Stage 1/2 Road Safety Audit

Stage 1/2 Road Safety Audit

Proposed Residential Development, Knocklyon Road, Dublin.

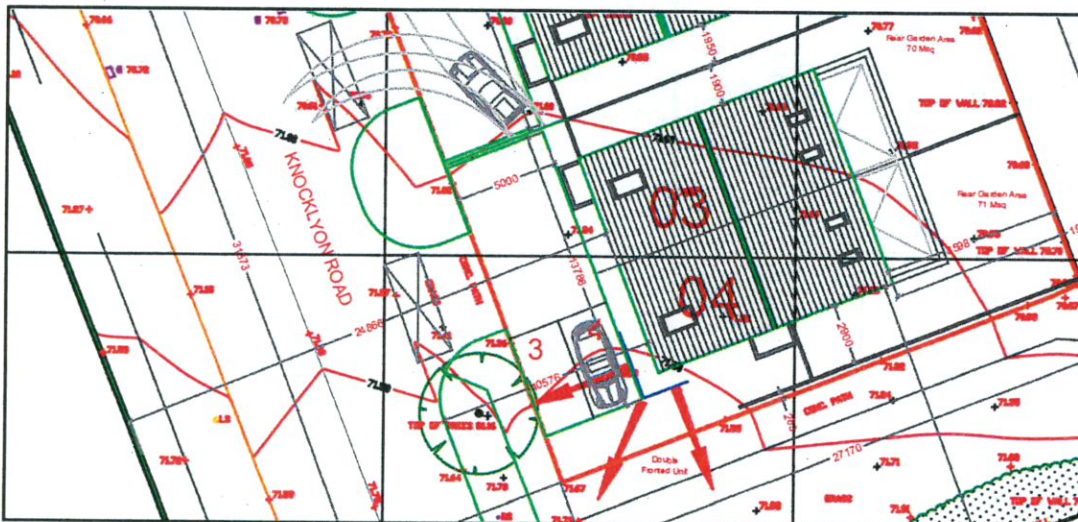
Location: Site Entrance/Exit

The audit team note from the design drawings that there are insufficient details provided in relation to sightlines, including the impact of proposed landscaping and existing vegetation at the entrances/exits. There is a potential safety risk to users of the development if trees, shrubs, or signage obstruct sightlines, potentially leading to side impact vehicle collisions.

The design team should ensure that landscaping does not impact on sightlines and visibility of pedestrians or vehicles within the site or at the accesses.

| Problem Reference in Safety Audit Report | To Be Completed by the Designer | | | To Be Completed Audit Team Leader |
|--|---------------------------------|----------------------------------|---|--|
| P1 | YRS | YRS | | |

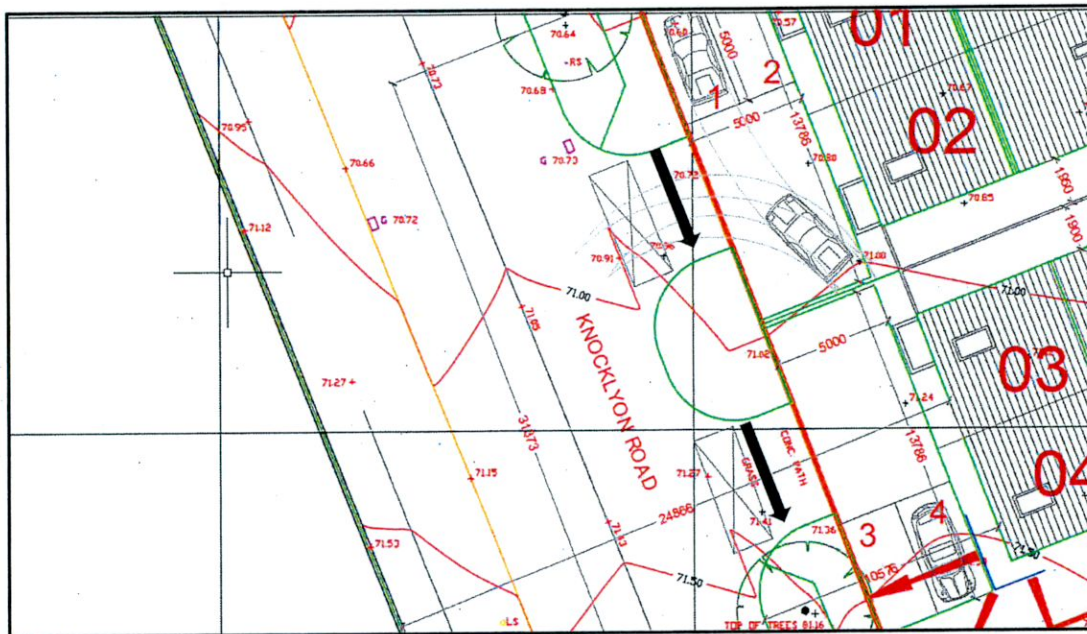
Location: Across Site Entrance/Exit

The audit team note from the drawings provided that it is unclear how the pedestrian concrete path will continue across the entrances of the development. It is unclear how pedestrian priority will be maintained at the driveway locations. Drivers may become confused as to priority of movement which could potentially result in vehicle-pedestrian conflict or an injury.

The design team should specify that footpaths continue across the entrances locations to clearly indicate pedestrian priority at these locations.

| Problem Reference in Safety Audit Report | To Be Completed by the Designer | | | To Be Completed Audit Team Leader |
|--|---------------------------------|----------------------------------|---|--|
| P2 | YRS | YRS | | |
